**COUNTY OF SAN MATEO
PLANNING AND BUILDING DEPARTMENT**

SUBJECT: EXECUTIVE SUMMARY: Consideration of a Design Review, Coastal Development, and Use Permit to construct a 748 sq. ft. addition to an existing 1,552 sq. ft. residence with reduced side yard setbacks and parking, on a 5,009 sq. ft. parcel, within the unincorporated community of Miramar. No trees have been proposed for removal. The project is not appealable to the California Coastal Commission.

County File Number: PLN 2020-00248 (Bursalyan)

EXTERIOR ELEVATIONS

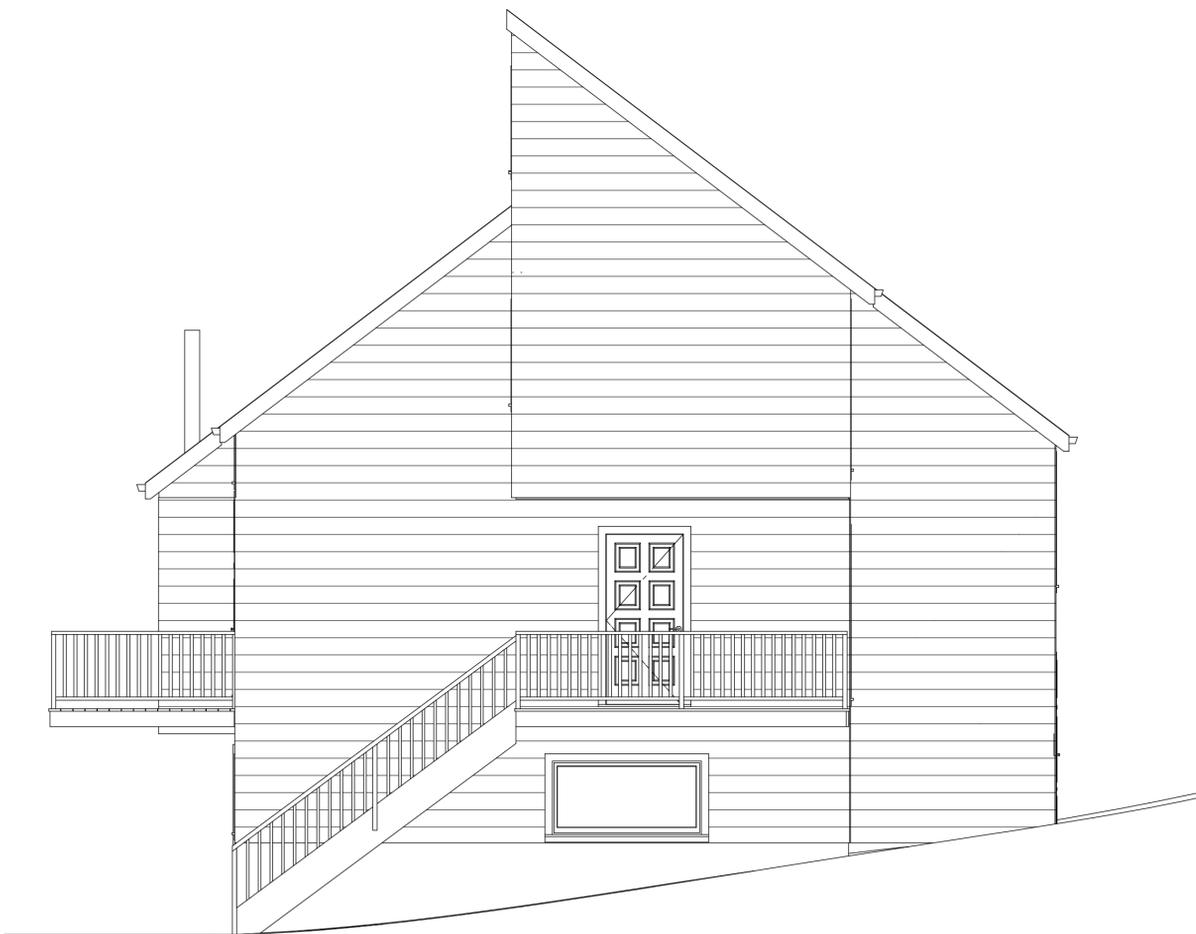
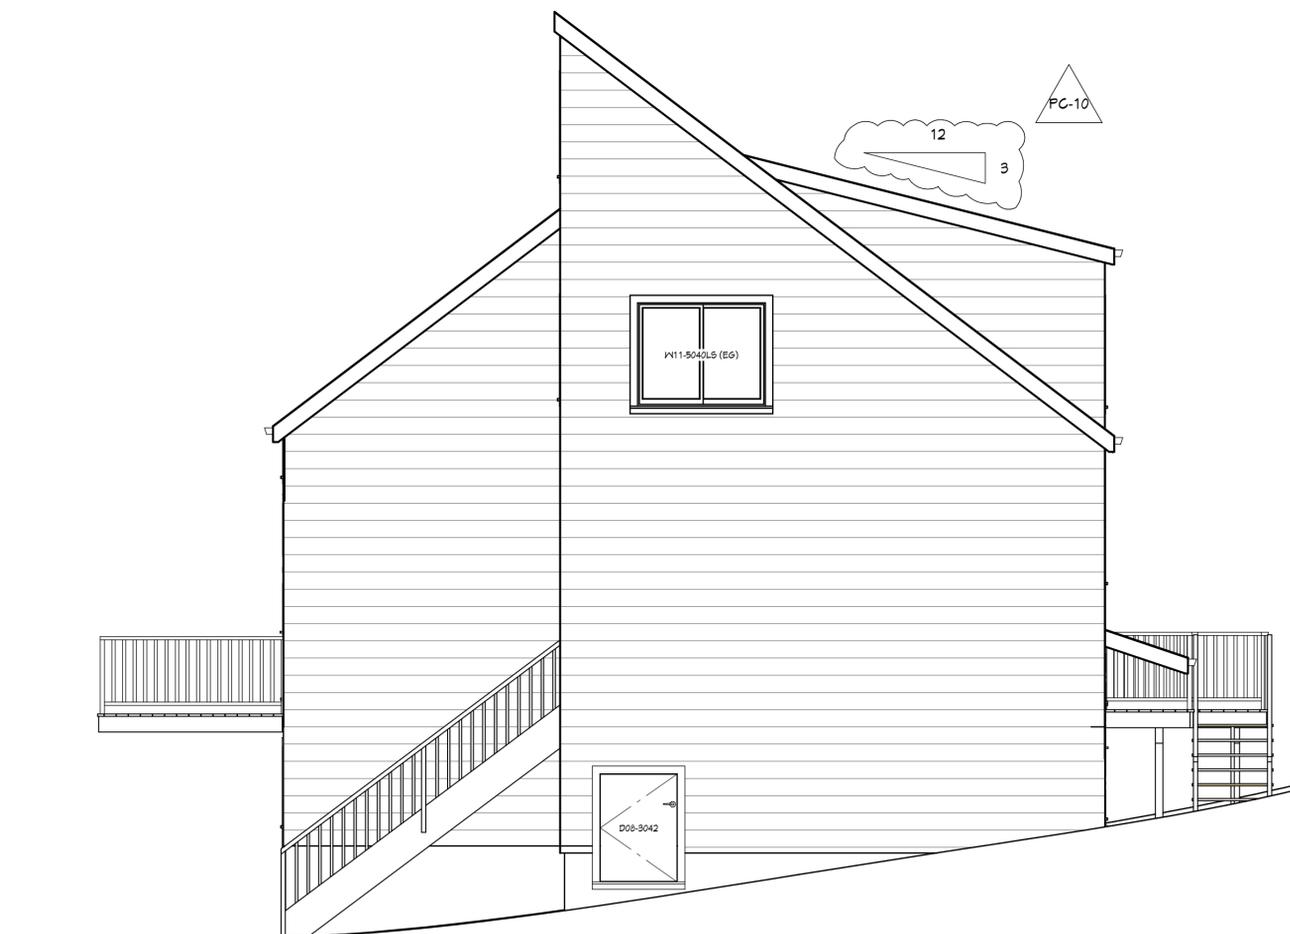
3. All material specifications and color selections shall be shown on Exterior Elevations.
4. Revise exterior lighting layout to include (1) dark sky compliant fixture at each exterior door, with the exception of (2) dark sky compliant fixtures at the existing front deck and (1) dark sky compliant fixture at the bottom of the stairs from the front Entry.

SECTION S5

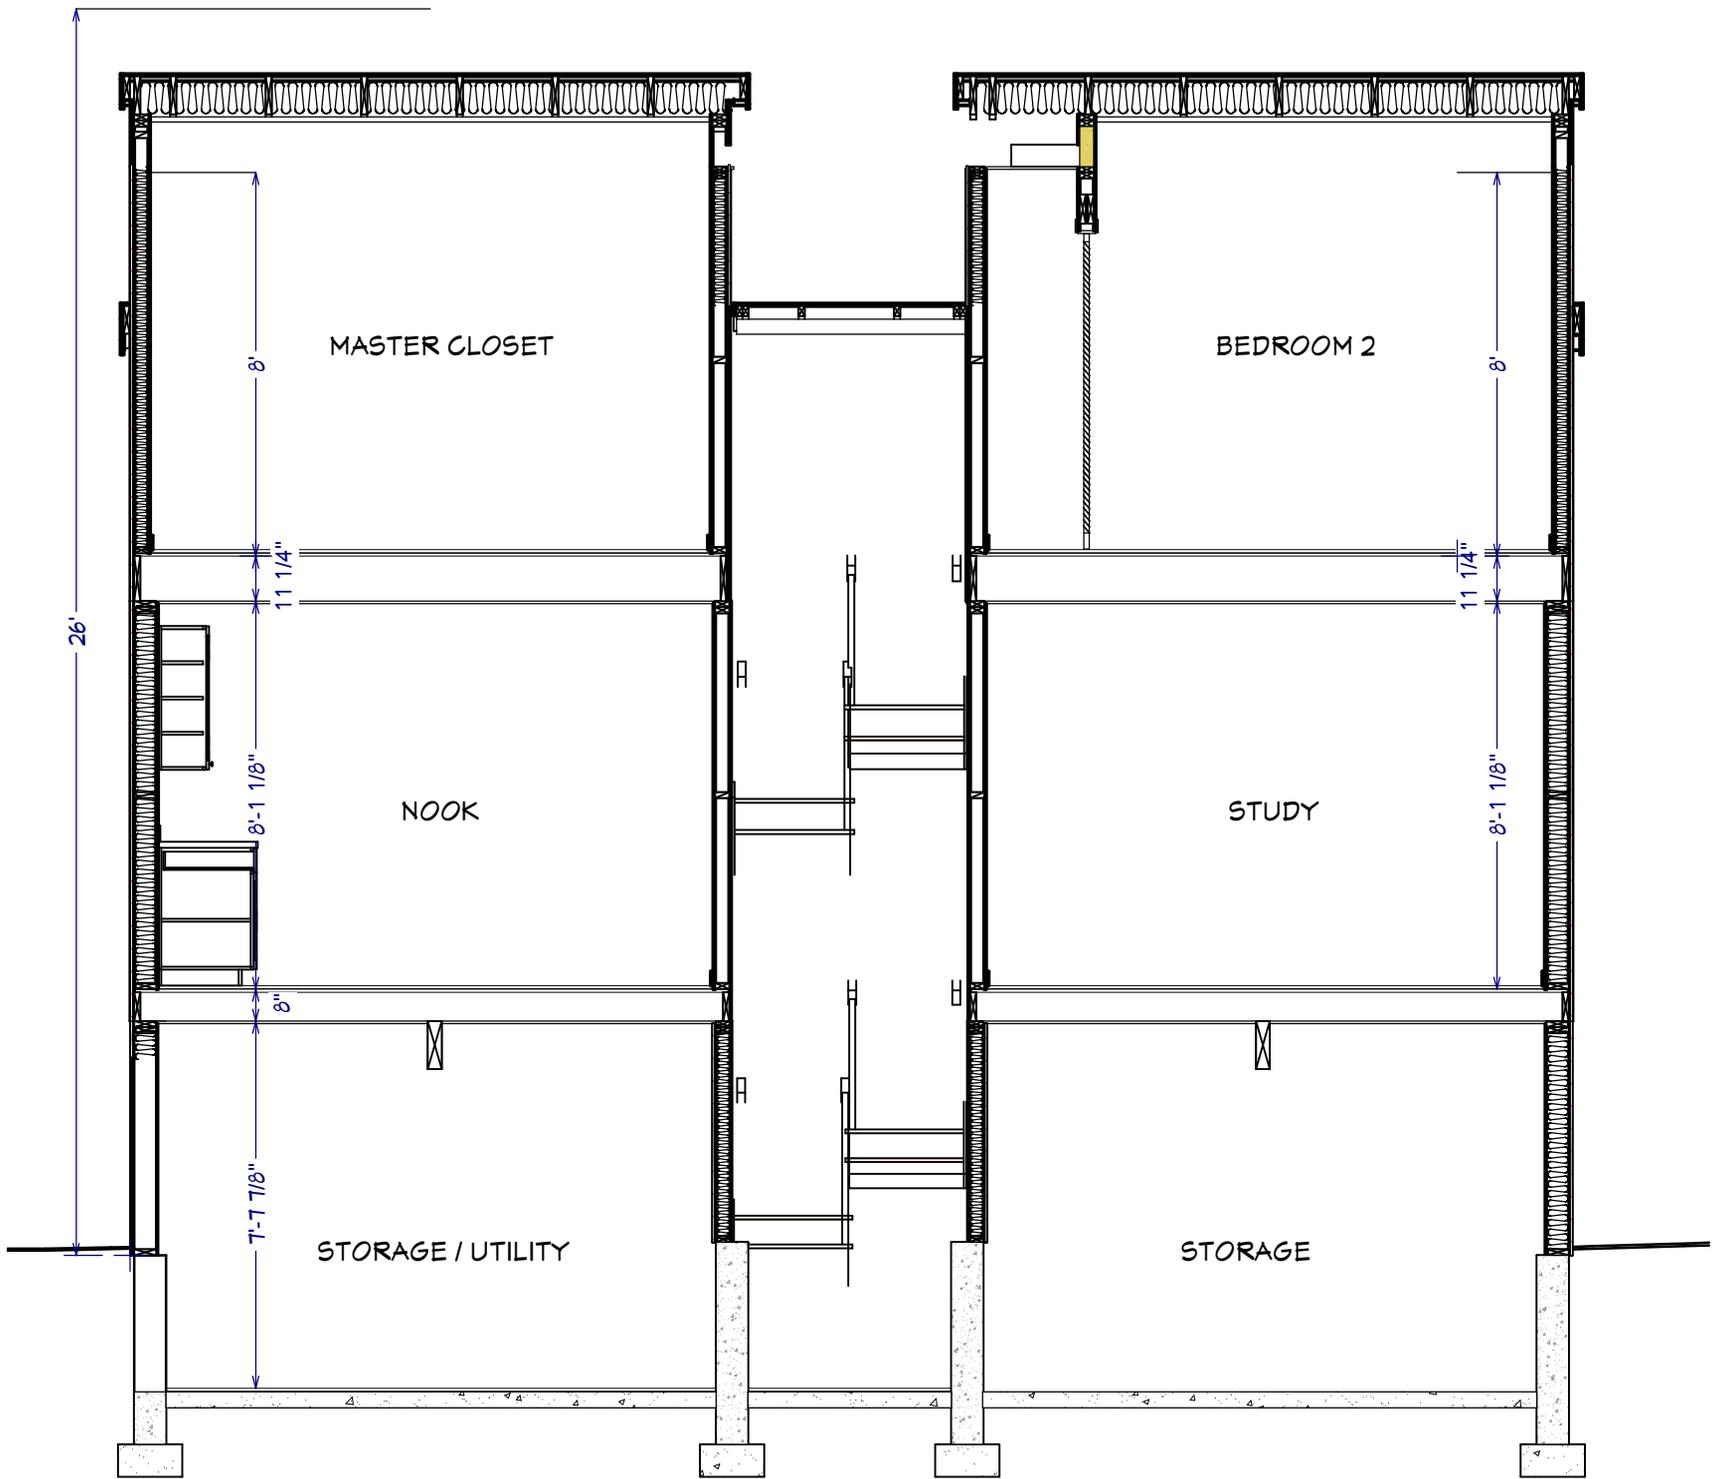
1. Proposed Gable dormers at rear second floor addition shall be changed to shed roof dormers. Plate height shall be 8'-0" above finished floor elevation, and top of shed roof where it meets the existing roof shall not exceed 26 feet above existing grade (refer to Section S5).
